MEMO

Date: June 5, 2026
To: Jack Ward
Quieter Home Program, Manager of Field Activities
From: Patrick Leroy
The Jones Payne Group, Inc.
Subject: RES # 381412.00
West Point Loma HOA Condos at 4532-4578 W. Point Loma Boulevard, San Diego, CA
Job No: Group 14.12
Cc: Design Team: JPG, HAP & PBS

ASSESSMENT REPORT:

NOTIFICATIONS, PRE-WORK AND BUILDING CODE OBSERVATIONS

4532 - 4546 BUILDING PLANS - PROPOSED CU LOCATIONS

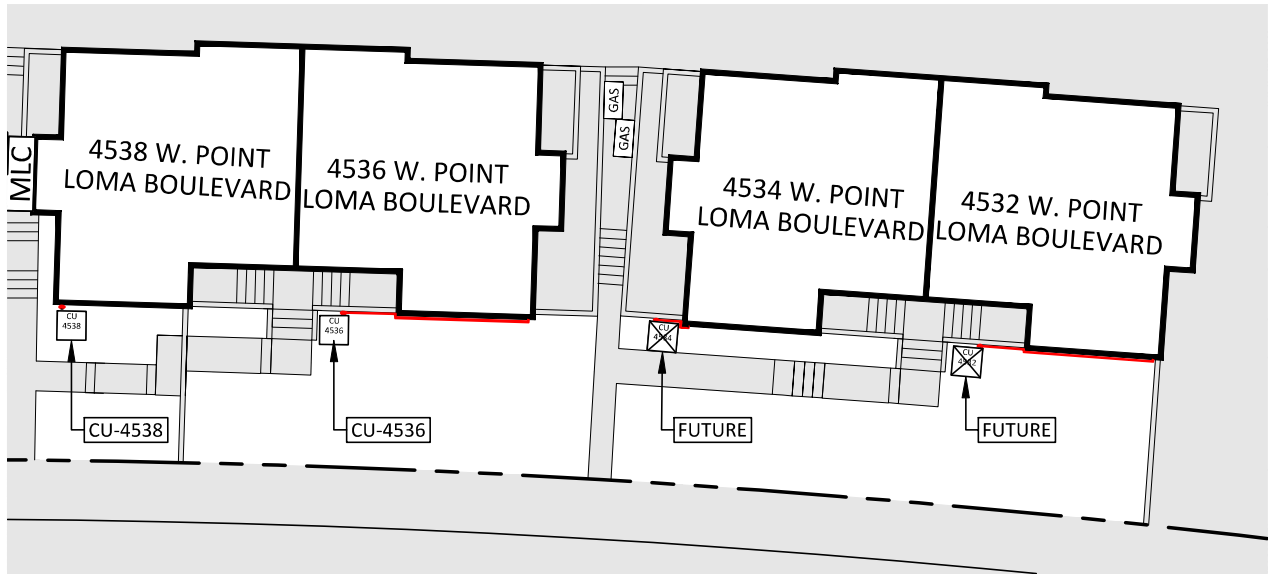
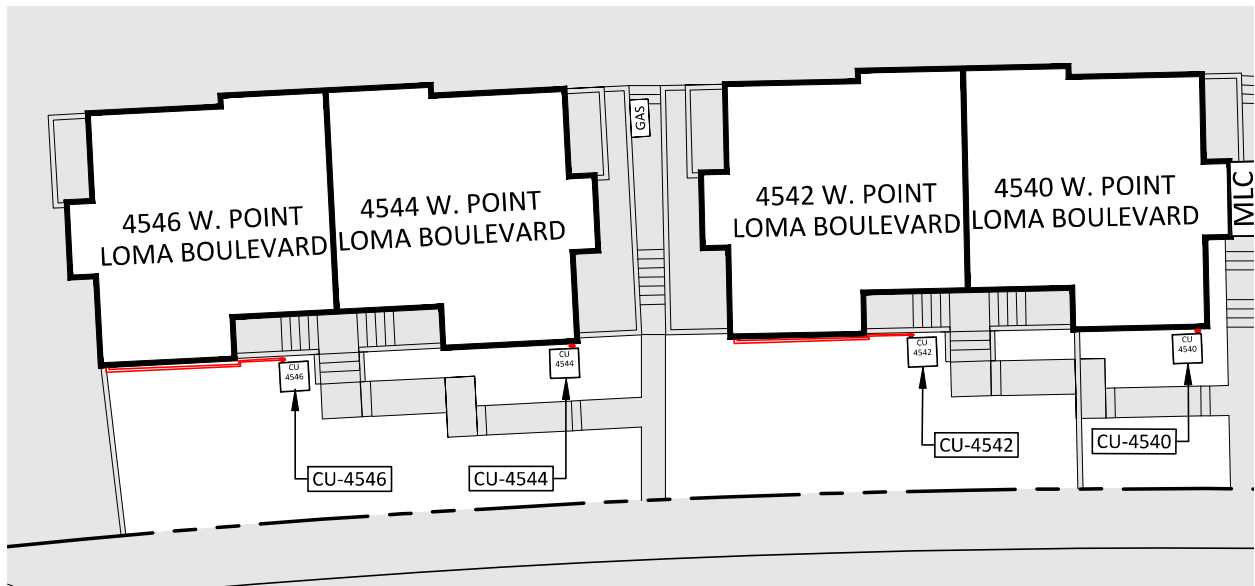
LOCATION:	ISSUE:	RECOMMENDATION:
<p>1. 4536 W. POINT LOMA BLVD - PROPOSED CONDENSING UNIT</p> 	<p>1. CONDENSING UNIT LOCATION THE DESIGN TEAM OBSERVED EXISTING LANDSCAPING & IRRIGATION AT THE PROPOSED CONDENSING UNIT LOCATION.</p>	<p>1. PRE-WORK: 1. REMOVE LANDSCAPING & IRRIGATION AT PROPOSED LOCATION TO ALLOW INSTALLATION OF NEW CONDENSING UNIT. 2. PROVIDE A CLEAR LEVEL WORKING SURFACE THAT IS AT LEAST 36" WIDE; 36" DEEP. NOTE: THE QUIETER HOME PROGRAM RECOMMENDS THE HOMEOWNER TO COMPLETE THIS ITEM AFTER THE CONTRACTORS FIELD MEASUREMENT VISIT (FMV).</p>
<p>2. 4538 W. POINT LOMA BLVD - PROPOSED CONDENSING UNIT</p> 	<p>2. CONDENSING UNIT LOCATION THE DESIGN TEAM OBSERVED EXISTING LANDSCAPING & IRRIGATION AT THE PROPOSED CONDENSING UNIT LOCATION.</p>	<p>2. PRE-WORK: 1. REMOVE LANDSCAPING & IRRIGATION AT PROPOSED LOCATION TO ALLOW INSTALLATION OF NEW CONDENSING UNIT. 2. PROVIDE A CLEAR LEVEL WORKING SURFACE THAT IS AT LEAST 36" WIDE; 36" DEEP. NOTE: THE QUIETER HOME PROGRAM RECOMMENDS THE HOMEOWNER TO COMPLETE THIS ITEM AFTER THE CONTRACTORS FIELD MEASUREMENT VISIT (FMV).</p>

<p>3. 4540 W. POINT LOMA BLVD - PROPOSED CONDENSING UNIT</p> 	<p>3. CONDENSING UNIT LOCATION THE DESIGN TEAM OBSERVED EXISTING LANDSCAPING & IRRIGATION AT THE PROPOSED CONDENSING UNIT LOCATION.</p>	<p>3. PRE-WORK: 1. REMOVE LANDSCAPING & IRRIGATION AT PROPOSED LOCATION TO ALLOW INSTALLATION OF NEW CONDENSING UNIT. 2. PROVIDE A CLEAR LEVEL WORKING SURFACE THAT IS AT LEAST 36" WIDE; 36" DEEP. NOTE: THE QUIETER HOME PROGRAM RECOMMENDS THE HOMEOWNER TO COMPLETE THIS ITEM AFTER THE CONTRACTORS FIELD MEASUREMENT VISIT (FMV).</p>

<p>4. 4542 W. POINT LOMA BLVD - PROPOSED CONDENSING UNIT</p> 	<p>4. CONDENSING UNIT LOCATION THE DESIGN TEAM OBSERVED EXISTING LANDSCAPING & IRRIGATION AT THE PROPOSED CONDENSING UNIT LOCATION.</p>	<p>4. PRE-WORK: 1. REMOVE LANDSCAPING & IRRIGATION AT PROPOSED LOCATION TO ALLOW INSTALLATION OF NEW CONDENSING UNIT. 2. PROVIDE A CLEAR LEVEL WORKING SURFACE THAT IS AT LEAST 36" WIDE; 36" DEEP. NOTE: THE QUIETER HOME PROGRAM RECOMMENDS THE HOMEOWNER TO COMPLETE THIS ITEM AFTER THE CONTRACTORS FIELD MEASUREMENT VISIT (FMV).</p>
<p>5. 4544 W. POINT LOMA BLVD - PROPOSED CONDENSING UNIT</p> 	<p>5. CONDENSING UNIT LOCATION THE DESIGN TEAM OBSERVED EXISTING LANDSCAPING & IRRIGATION AT THE PROPOSED CONDENSING UNIT LOCATION.</p>	<p>5. PRE-WORK: 1. REMOVE LANDSCAPING & IRRIGATION AT PROPOSED LOCATION TO ALLOW INSTALLATION OF NEW CONDENSING UNIT. 2. PROVIDE A CLEAR LEVEL WORKING SURFACE THAT IS AT LEAST 36" WIDE; 36" DEEP. NOTE: THE QUIETER HOME PROGRAM RECOMMENDS THE HOMEOWNER TO COMPLETE THIS ITEM AFTER THE CONTRACTORS FIELD MEASUREMENT VISIT (FMV).</p>

<p>6. 4546 W. POINT LOMA BLVD - PROPOSED CONDENSING UNIT</p> 	<p>6. CONDENSING UNIT LOCATION THE DESIGN TEAM OBSERVED EXISTING LANDSCAPING & IRRIGATION AT THE PROPOSED CONDENSING UNIT LOCATION.</p>	<p>6. PRE-WORK: 1. REMOVE LANDSCAPING & IRRIGATION AT PROPOSED LOCATION TO ALLOW INSTALLATION OF NEW CONDENSING UNIT. 2. PROVIDE A CLEAR LEVEL WORKING SURFACE THAT IS AT LEAST 36" WIDE; 36" DEEP. NOTE: THE QUIETER HOME PROGRAM RECOMMENDS THE HOMEOWNER TO COMPLETE THIS ITEM AFTER THE CONTRACTORS FIELD MEASUREMENT VISIT (FMV).</p>

4548 - 4578 BUILDING PLANS - PROPOSED CU LOCATIONS

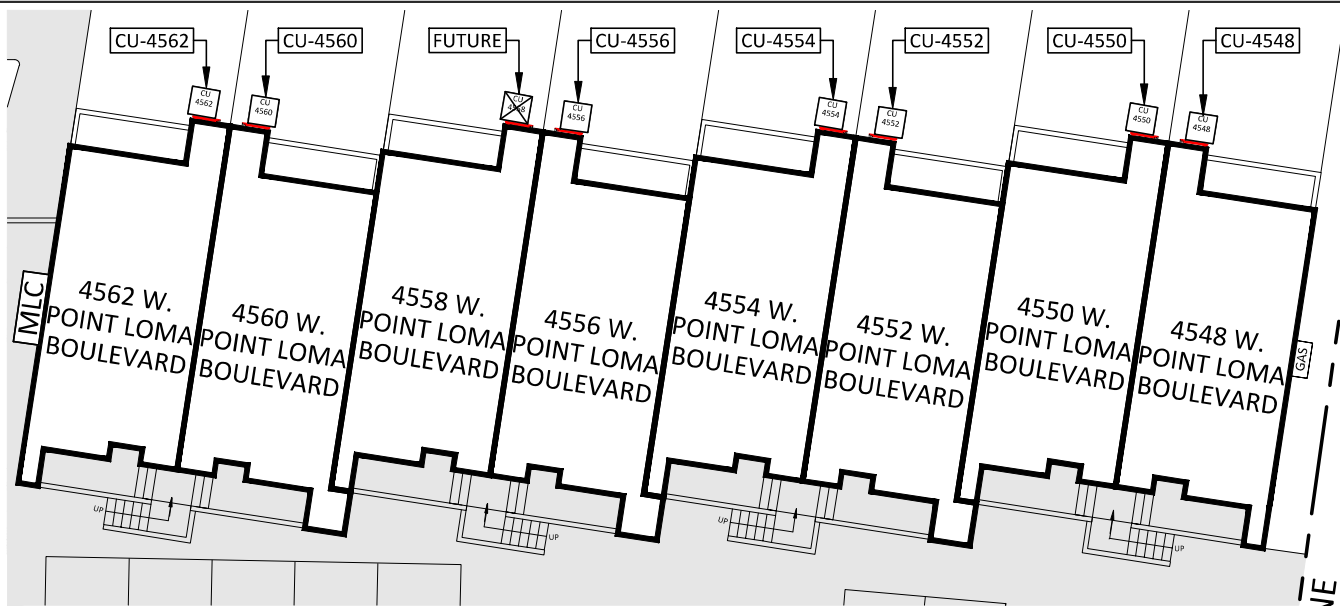
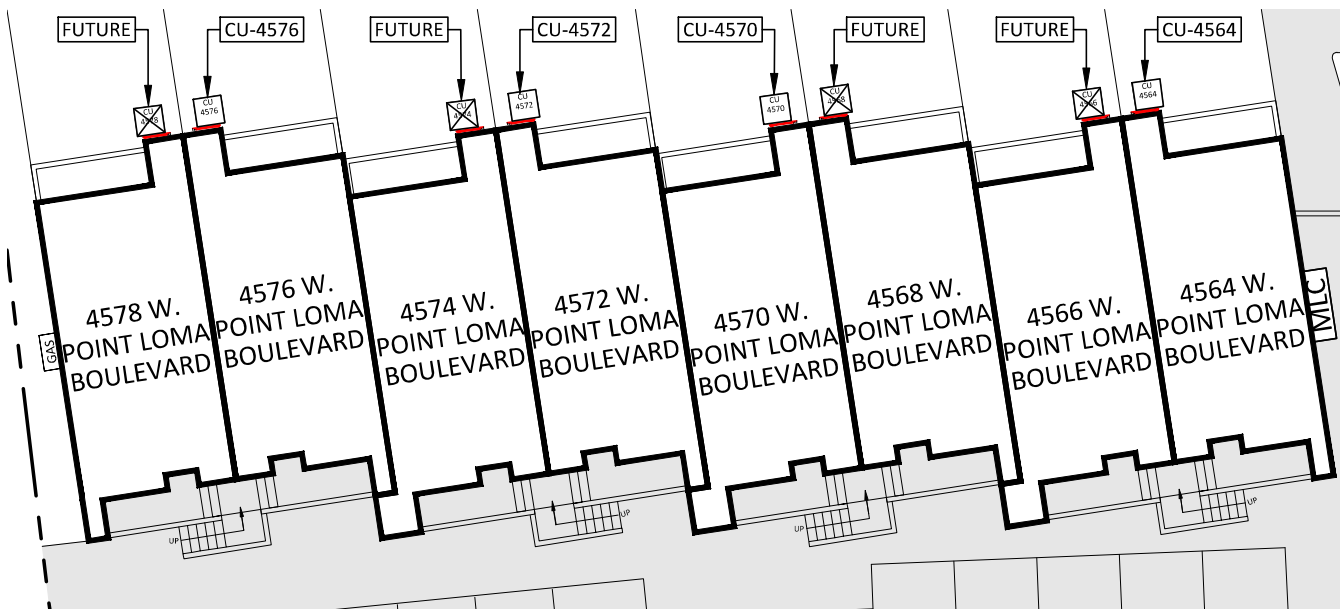
<p>6. 4548-4578 W. POINT LOMA BOULEVARD - FRONT BEDROOM AT LOWER FLOOR</p> 	<p>6. BEDROOM MECHANICAL DUCT ROUTING OBSTRUCTED THE DESIGN TEAM OBSERVED THAT EXISTING DROP CEILINGS AND SOFFITS PREVENT THE INSTALLATION OF NEW DUCTWORK FROM THE PROPOSED AIR CONDITIONING SYSTEM TO BEDROOM 2.</p>	<p>6. NOTIFICATION: THE QUIETER HOME PROGRAM IS UNABLE TO PROVIDE AIR CONDITIONING TO BEDROOM 2 DUE TO EXISTING DROP CEILINGS AND SOFFITS THAT OBSTRUCT THE REQUIRED DUCTWORK ROUTING.</p>
--	---	---
